3MS (2 & 4 pole) Performance Comparison

CURVE / C3MSPERF

3500 RPM - 2 POLE

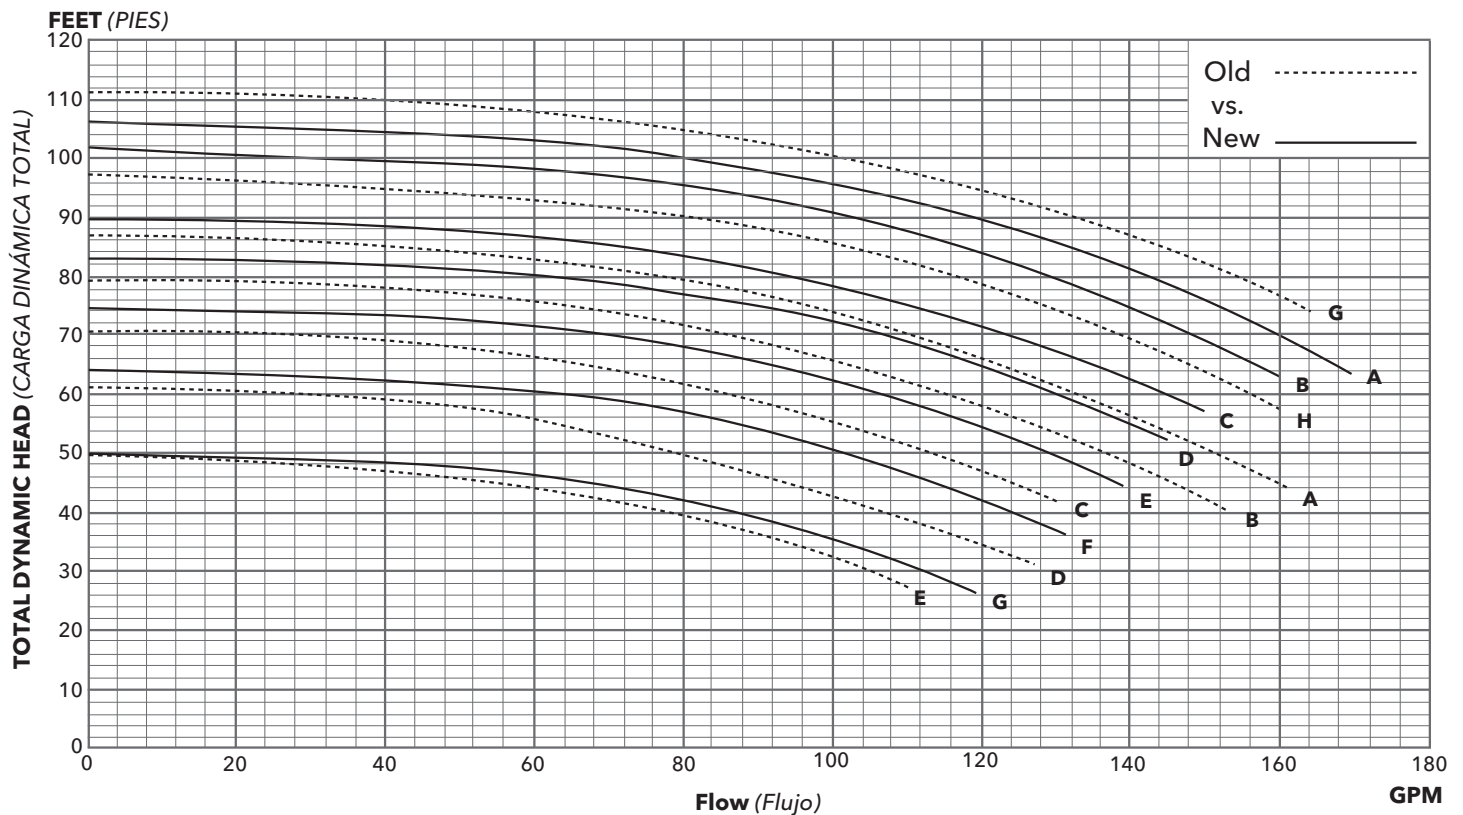
Previous Impeller	Previous Impeller Dia. (in)	New Impeller	New Impeller Dia. (in)
A	4.75	A	5.13
B	4.63	B	5.00
C	4.38	C	4.75
D	4.06	D	4.50
E	3.63	E	4.38
F		F	4.06
G	5.38	G	3.63
H	5.00

1750 RPM - 4 POLE

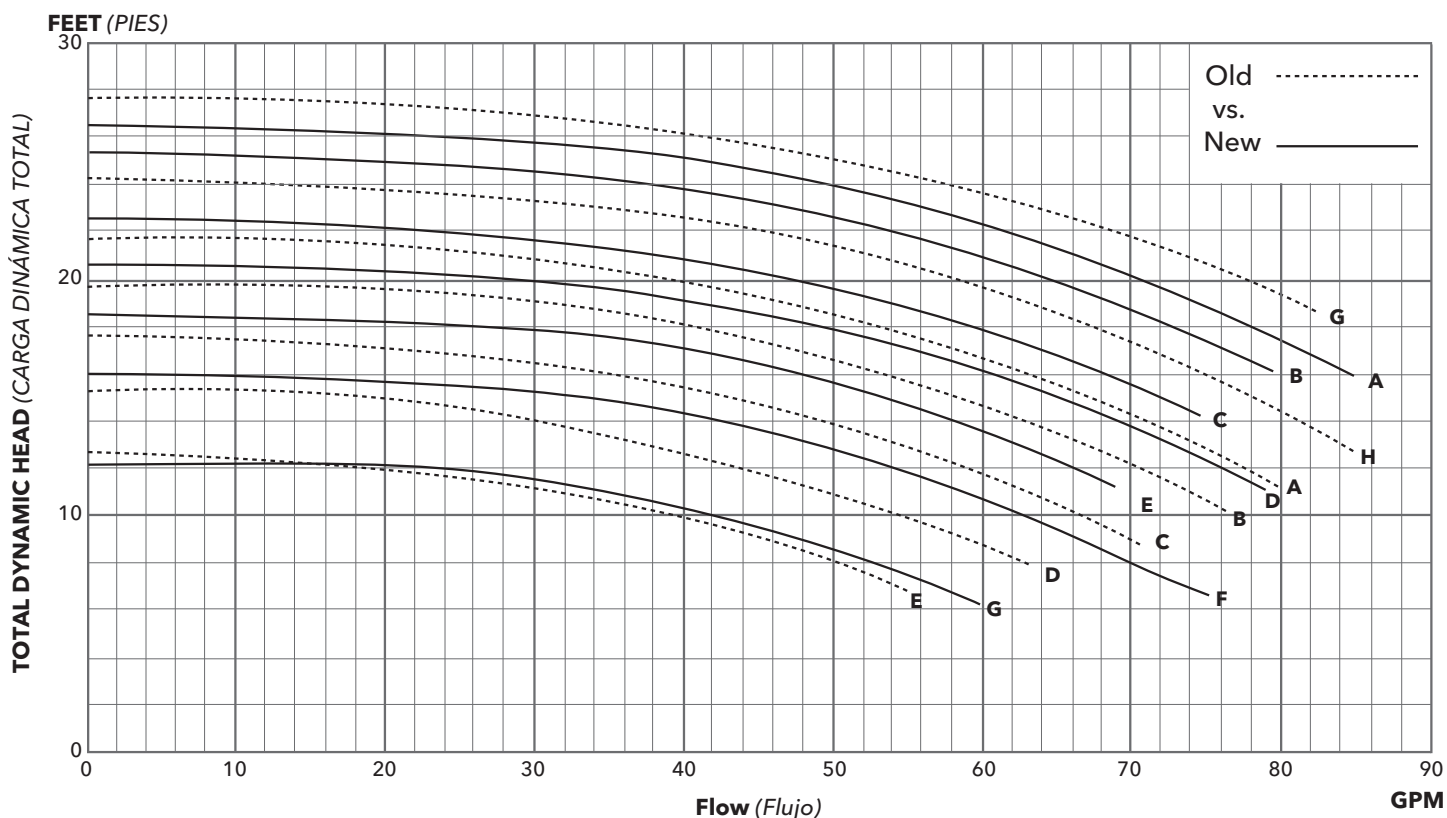
Previous Impeller	Previous Impeller Dia. (in)	New Impeller	New Impeller Dia. (in)
A	4.75	A	5.13
B	4.63	B	5.00
C	4.38	C	4.75
D	4.06	D	4.50
E	3.63	E	4.38
F		F	4.06
G	5.38	G	3.63
H	5.00
